PUR-1436
ADDENDUM NO. 2
INVITATION TO BID

HAGERSTOWN REGIONAL AIRPORT TERMINAL BUILDING EXPANSION

DATE: Monday, August 5, 2019

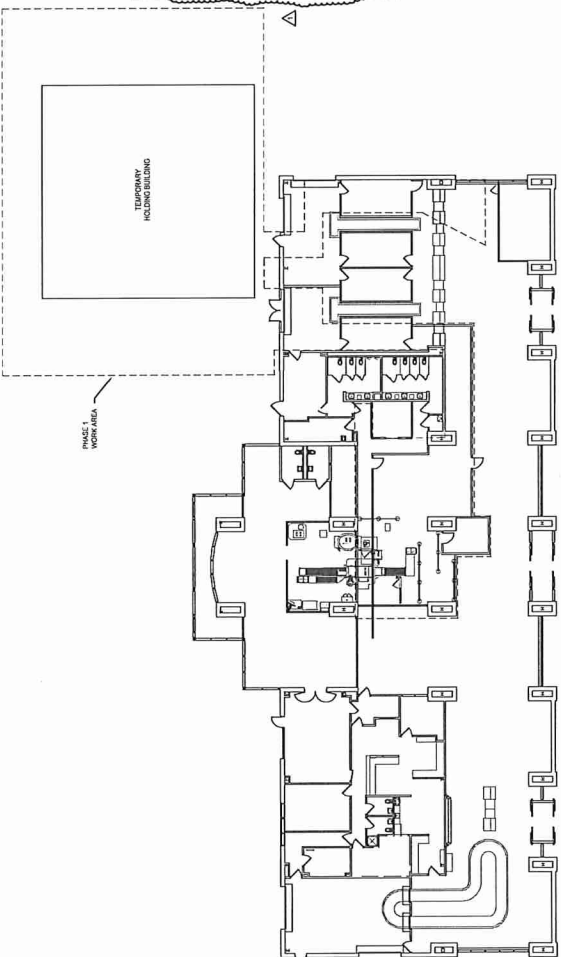
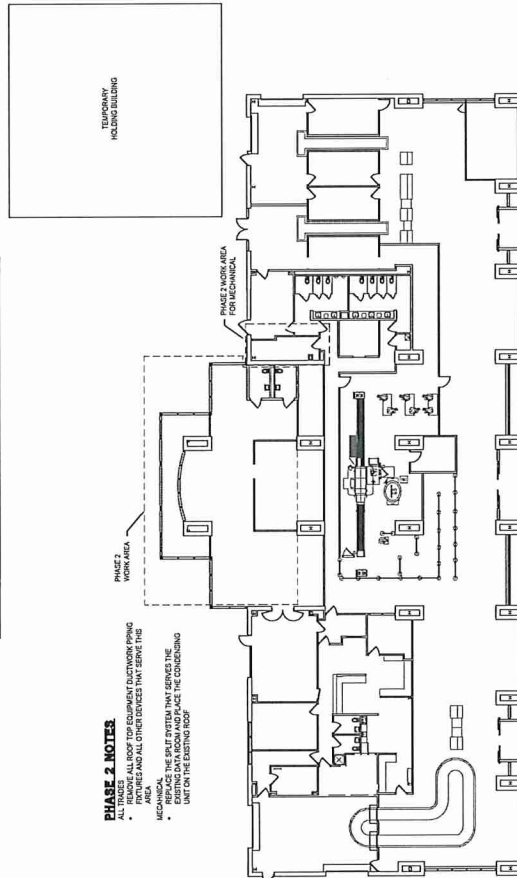
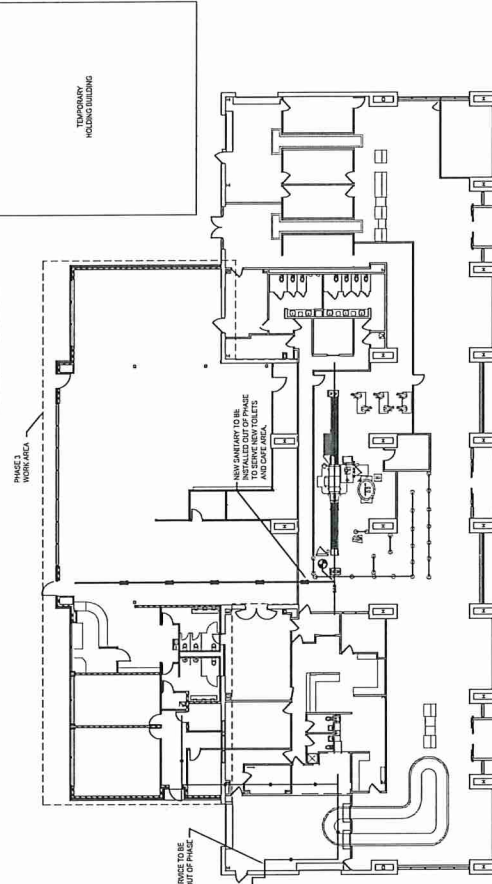
ITEM NO. 6: Inquiry: (Page GN03.104, Phase 1 Note) - Please provide the source and routing and related engineering that is associated with providing temporary electric (also to the extent needed - fire alarm, phone, intranet, access control and CCTV) for the temporary hold building. Please include routing – so that we can quantify the necessary select demolition and replacement of exterior and interior existing finishes to accomplish this element of work.

Response: Please see revised Drawing GN03.104 with updated notes and requirements for temporary utilities.

PROJECT TITLE: **TERMINAL BUILDING EXPANSION**
 SHEET TITLE: **SITE PLAN**
 SCALE: 1" = 20'

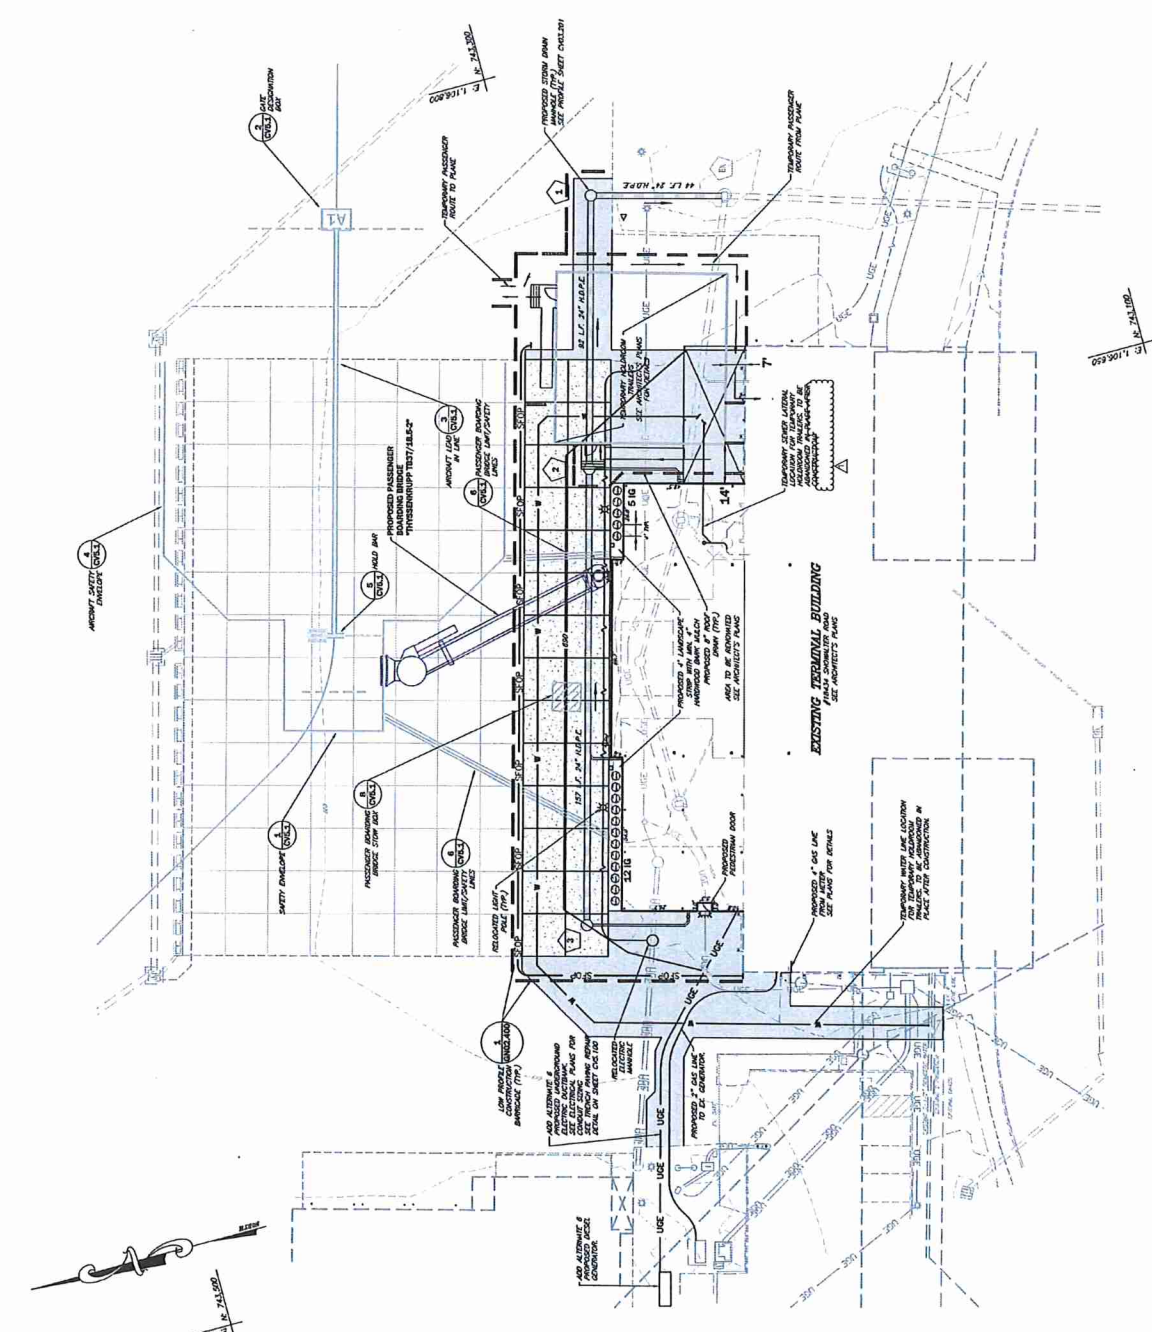
ITEM NO. 4: *Inquiry:* Page CV03.100 suggests that the connection point for the temporary hold room sanitary sewer is on the east side of the existing terminal and directs us to refer to Mechanical Drawings. Page PL02.100 shows the sanitary piping but it does not provide for the temporary hold room and Phase 1 notes on page GN03.104 state that no plumbing or fire protection work is required during phase 1. Further, there is no sanitary sewer illustrated on page PL02.100 anywhere near where the temporary hold building is to be located (other than an abandon grease interceptor that is shown on page CV01.001 but is made clear where its effluent is piped). Please provide a design for how we are to provide sanitary sewer to the temporary hold building. Please include routing – so that we can quantify the necessary select demolition and replacement of exterior and interior existing finishes to accomplish this element of work.

ITEM NO. 5: Inquiry: (Page CV03.100) To the extent that heat trace and insulation and related electric power is required to protect a potable water circuit for the temporary hold building – please provide a design.

Response: Notes provided on Drawing PL01.100 for temporary sanitary connection to the temporary holding room. Please see revised PL01.100 and revised CV03.100 Drawings.

Response: Temporary waterline to be buried with minimum 36” cover. Heat Trace and insulation not required.
